# UNITED STATES PATENT AND TRADEMARK OFFICE

APPLICATION NO.	FILING DATE	FIRST NAMED INVENTOR	ATTORNEY DOCKET NO.	CONFIRMATION NO.
10/792,090	03/04/2004	Dong-Hoon Kim	6192.0331.US	4090

# Office Action Summary

## DETAILED ACTION

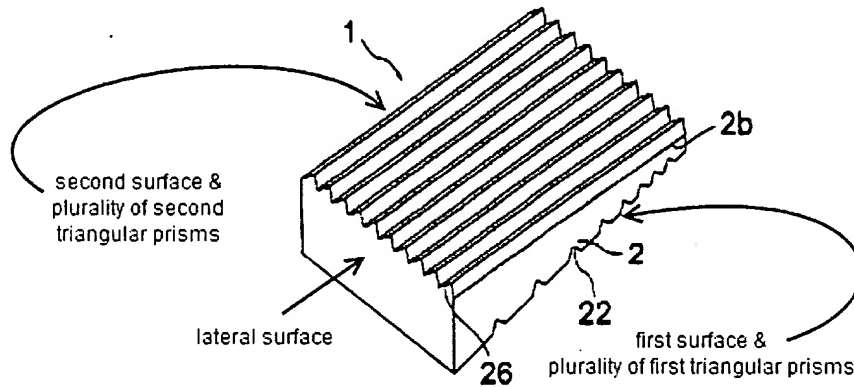
- At least one lateral surface [Figures 9-11] connecting the first and second main surfaces;
- A plurality of first triangular surfaces [Figures 9-11: (22)] formed on the first main surface and aligned in a row to a first direction, each having an obtuse protrusion [Column 16, Lines 5-21] and a first vertex angle [Figure 3; Column 16, Lines 5-21];  
and
- A plurality of second triangular surfaces [Figures 9-11: (26, 261)] formed on the second main surface and aligned in a row to a second direction, each having an obtuse protrusion [Column 22, Lines 13-14] and a second vertex angle different from the first vertex angle [Figure 10; Column 22, Lines 13-14];
- Wherein the first vertex angle ranges from about 100° to about 120° [Column 16, Lines 19-21], and the second vertex angle ranges from about 120° to about 140° [Column 22, Lines 13-14].

6. With regards to Claim 22, Kohara discloses the first vertex angle being obtuse [Column 16, Lines 5-21].
7. With regards to Claim 24, Kohara discloses the first vertex angle being about 108 degrees [Column 16, Lines 5-21].
8. With regards to Claim 25, Kohara discloses the second vertex angle being obtuse [Column 22, Lines 13-14].
9. With regards to Claim 27, Kohara discloses the second vertex angle being about 135 degrees [Column 22, Lines 13-14].
10. With regards to Claim 28, Kohara discloses the second direction being substantially perpendicular to the first direction [Figures 9-11; note drawing above].

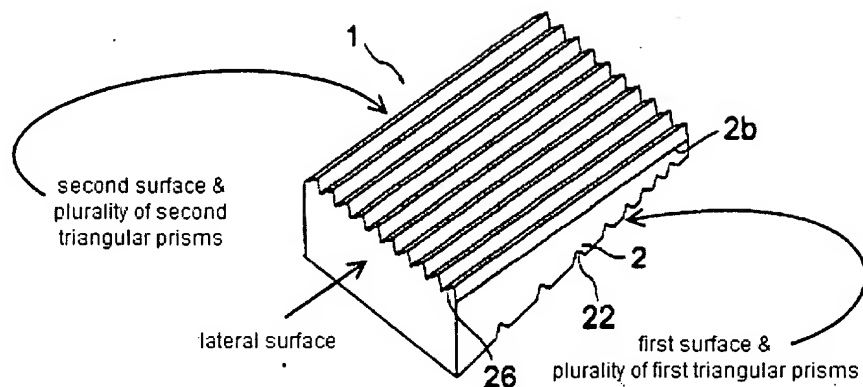
Large teaches a light guide plate having a plurality of first prisms [Figure 1: (2)] including first and second prism surfaces [Figures 1&4: (5)] with concavo-convex patterns/curved vertex ridge. In addition, Large teaches the concavo-convex pattern/curved vertex ridge being a triangular prism shape, but does not specifically teach said pattern/curved

vertex ridge having a rounded corner or being of varying height. However, it would have been obvious to one having ordinary skill in the art at the time the invention was made to modify the concavo-convex pattern/curved vertex ridge to have a rounded corner or being of varying height, since it has been held to be within the general skill of a worker that mere change of form or shape of an invention involves only routine skill in the art. *Span-Deck Inc. v. Fab-Con, Inc.* (CA 8, 1982) 215USPQ 835. In this case, providing a rounded corner or being of varying height would produce a different or desired optical effect.
